Project	IEEE 802.16 Broadband Wireless Access Working Group < http://ieee802.org/16 >	
Title	Correction to AMC pilot pattern definition	
Date Submitted	2005-05-03	
Source(s)	Yuval Lomnitz Uri Perlmutter Dov Andelman Intel.	Yuval.Lomnitz@intel.com Uri.PerlMutter@intel.com Dov.Andelman@intel.com
Re:	IEEE P802.16-2004/Cor1-D2	
Abstract	Correction to AMC pilot pattern definition	
Purpose	Adopt changes	
Notice	This document has been prepared to assist IEEE 802.16. It is offered as a basis for discussion and is not binding on the contributing individual(s) or organization(s). The material in this document is subject to change in form and content after further study. The contributor(s) reserve(s) the right to add, amend or withdraw material contained herein.	
Release	The contributor grants a free, irrevocable license to the IEEE to incorporate material contained in this contribution, and any modifications thereof, in the creation of an IEEE Standards publication; to copyright in the IEEE's name any IEEE Standards publication even though it may include portions of this contribution; and at the IEEE's sole discretion to permit others to reproduce in whole or in part the resulting IEEE Stand

Current situation (example for AMC 2x3, showing only 1 subchannel)

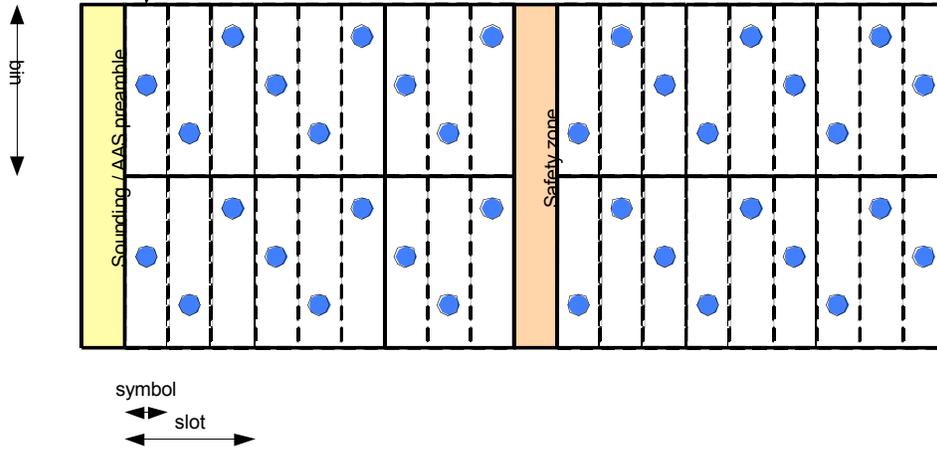
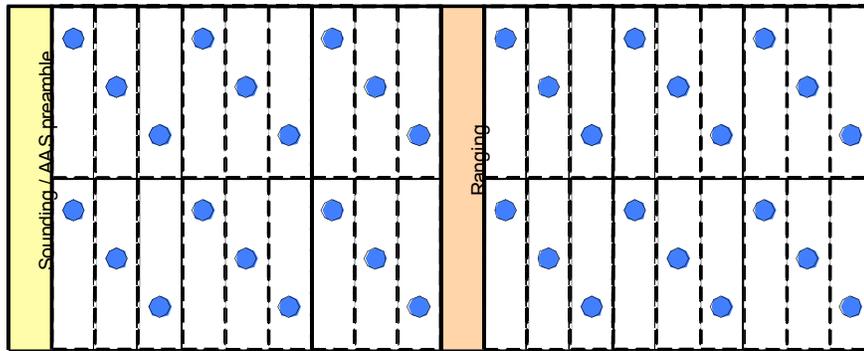
The AMC pilot location is based on symbol index from beginning of zone ($9k+3m+1$). This definition doesn't take into account special symbols (preamble, sounding, etc).

The problems in the current definition are:

- In the UL, there are symbols in which are entirely filled by rectangular allocations (e.g. Sounding, Ranging (not in AMC), Safety/PAPR reduction zones). In these symbols there are no slots, and the counting of slots resumes after these symbols (see clarifications done in 802.16Cor1/D2, 8.4.4.5). The current AMC pilot structure ignores this fact, so although the actual data contents (slots) is shifted, the pilots remain in same locations, which means that they move relative to the data slots, as shown in diagram below.
- In the DL, MIMO midamble or AAS preambles may cause similar phenomenon, of shifting the pilot pattern (or more accurately shifting the data subcarriers without similar shift of pilots).

Initial phase depends on number of symbols is DL subframe

After correction

The simplest way is to define m as symbol offset from start of slot epoch, but in order to be consistent with OFUSC and with all AMC tile structures, we propose to define that m is the symbol offset from the start of the current zone, counting only data symbols (i.e. Safety zones, Sounding symbols, preambles, etc are not counted).
